SECTION 00 91 13.1

ADDENDUM NO. 1

ROSS GARAGE DEMOLITION AND
TEMPORARY SURFACE RESTORATION
PHASE 1

**ROSS GARAGE
ELECTRICAL SITE
DEMOLITION PLAN**

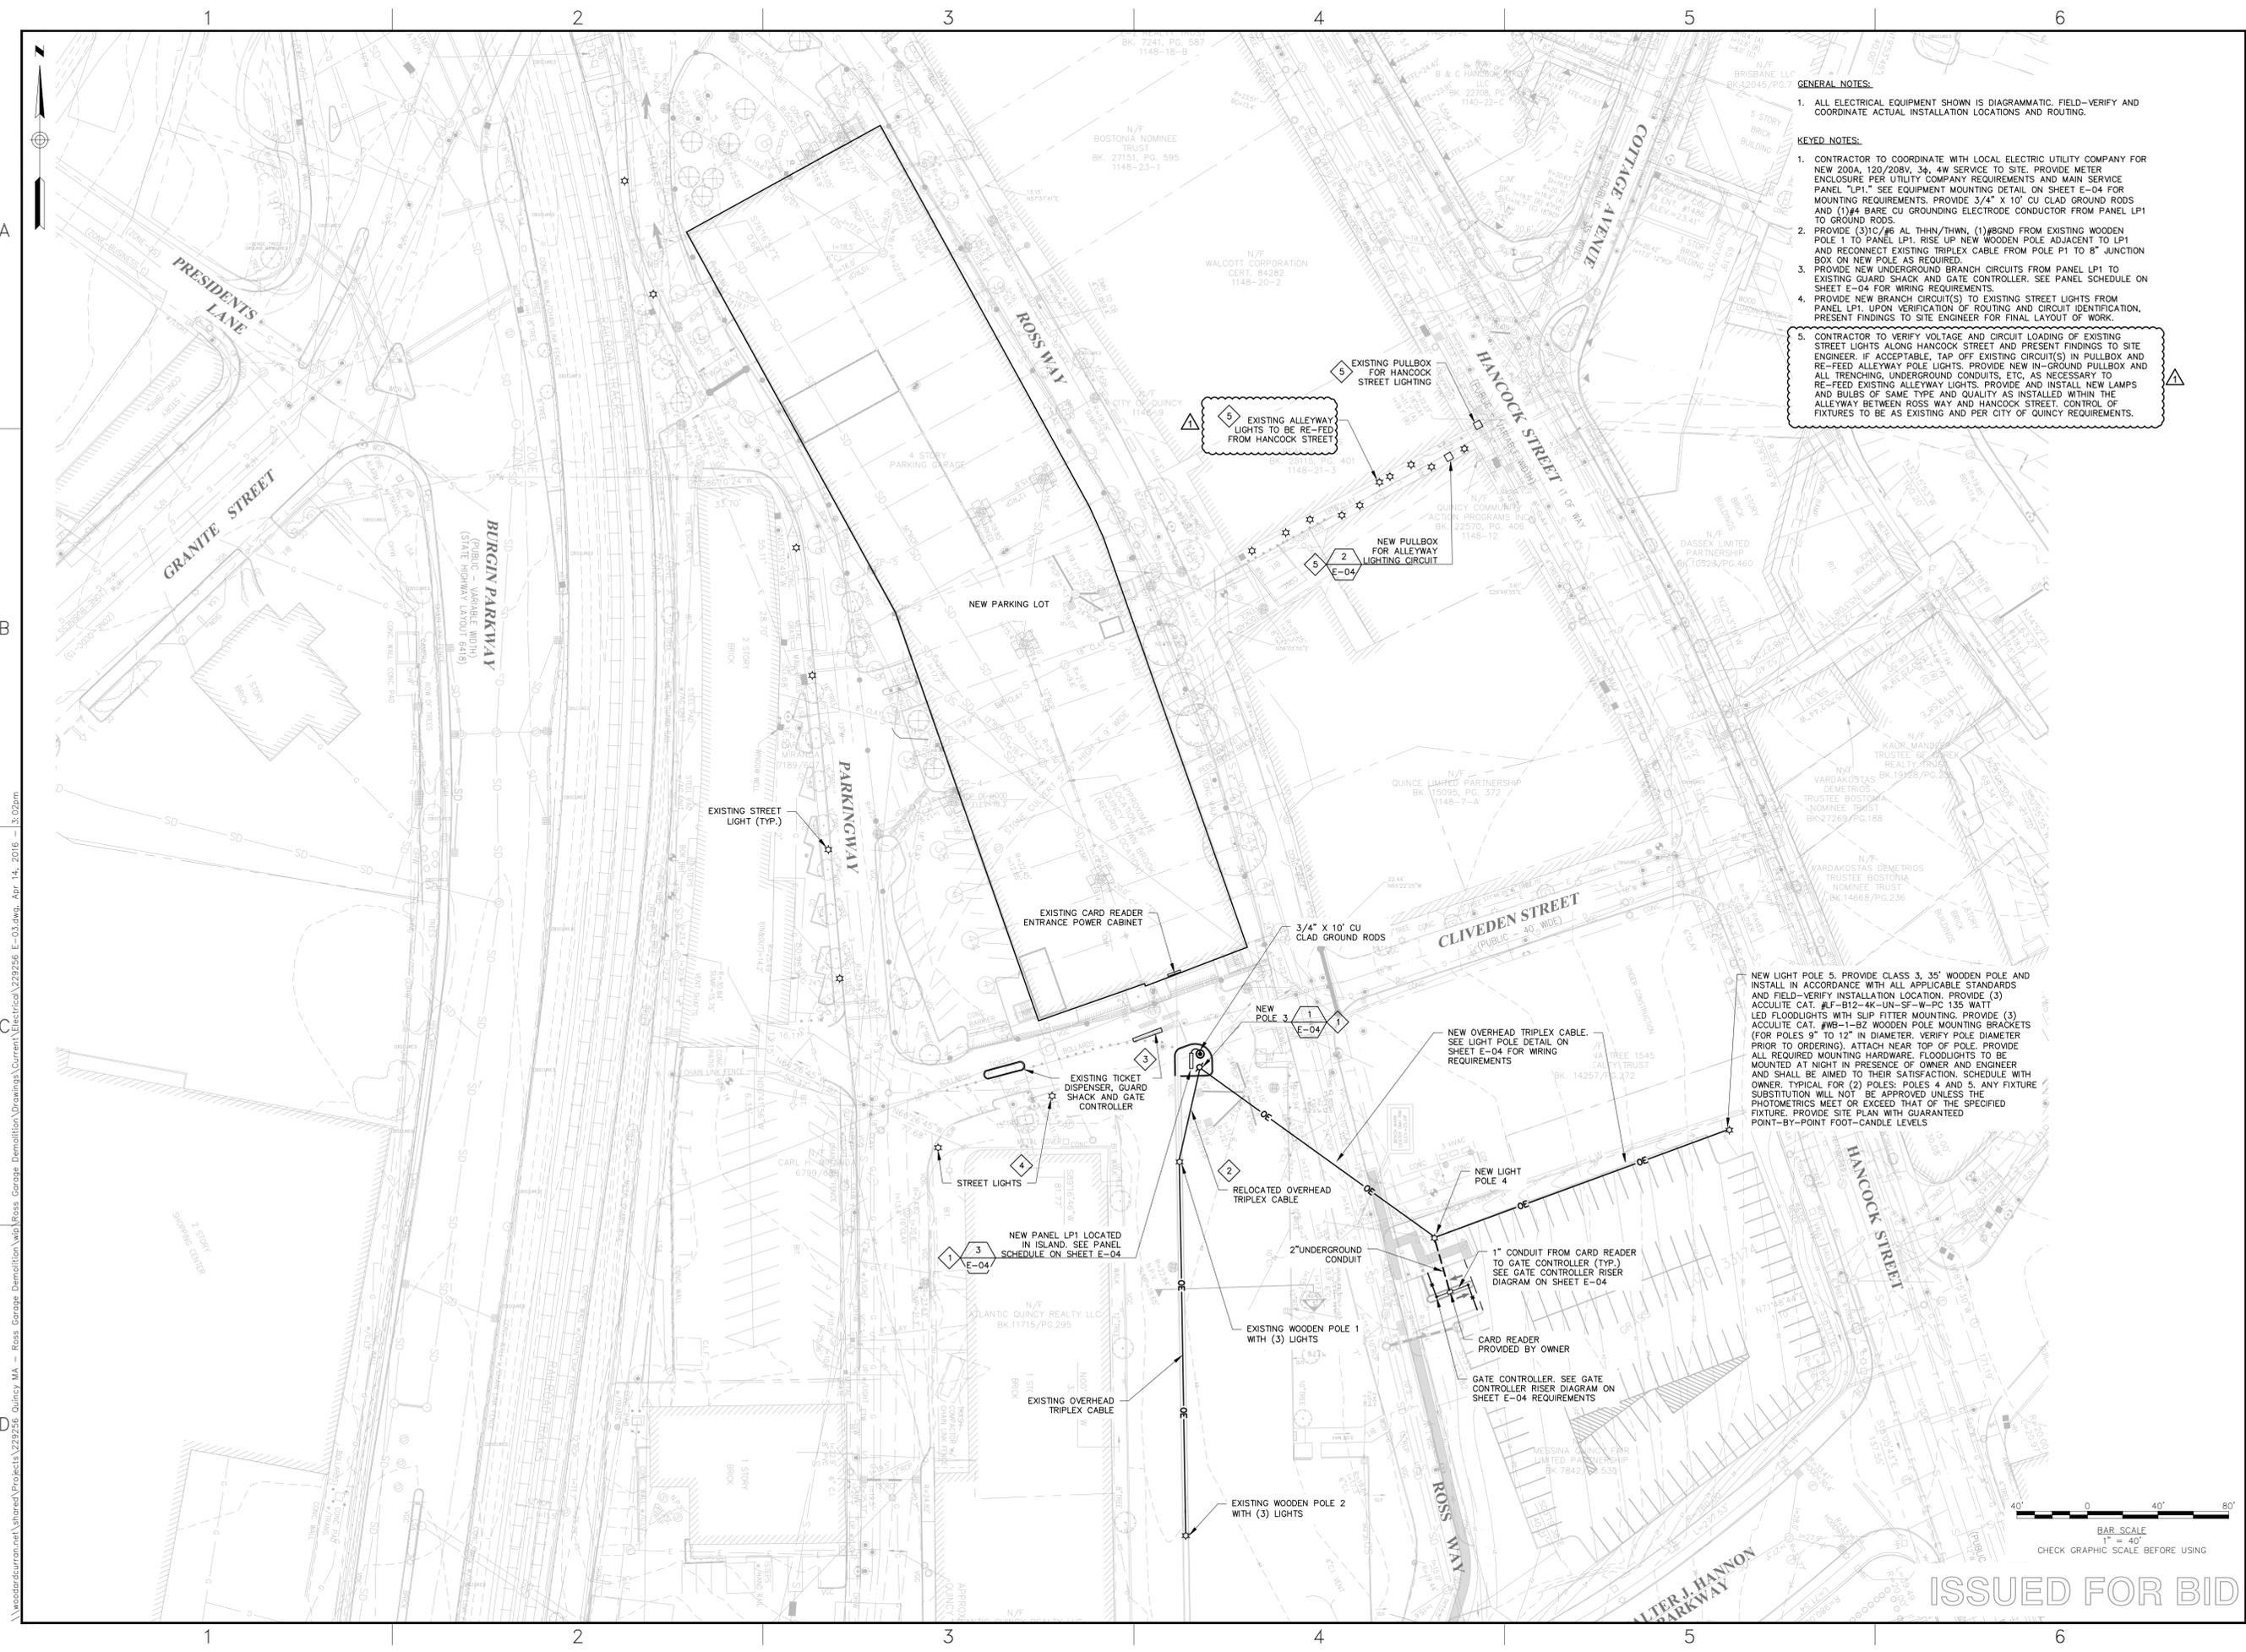
5. *"On the electrical plan E-02 if you look at the alleyway it shows 10 existing light poles to be disconnected and replaced refer to E-03 for the lighting. On plan E-03 it refers to note 5 which tells us to replace the lighting with the City of Quincy standard poles and lights however I cannot find what that would be to purchase. Can you please provide a specification for the poles and light heads for us to purchase and replace?"*

Answer: The Bid Documents are effectively modified by Addendum #1 to refine the scope of work for the alleyway light as indicated by note #5 on Plan sheet E-03 to delete the requirement "provide new light poles and fixtures" and "provide new light pole bases" and add "provision and installation of new lamps and bulbs of same type and quality as installed within the alleyway between Ross Way and Hancock Street" as previously indicated and described within Measurement and Payment Item 6 Electrical Restoration.
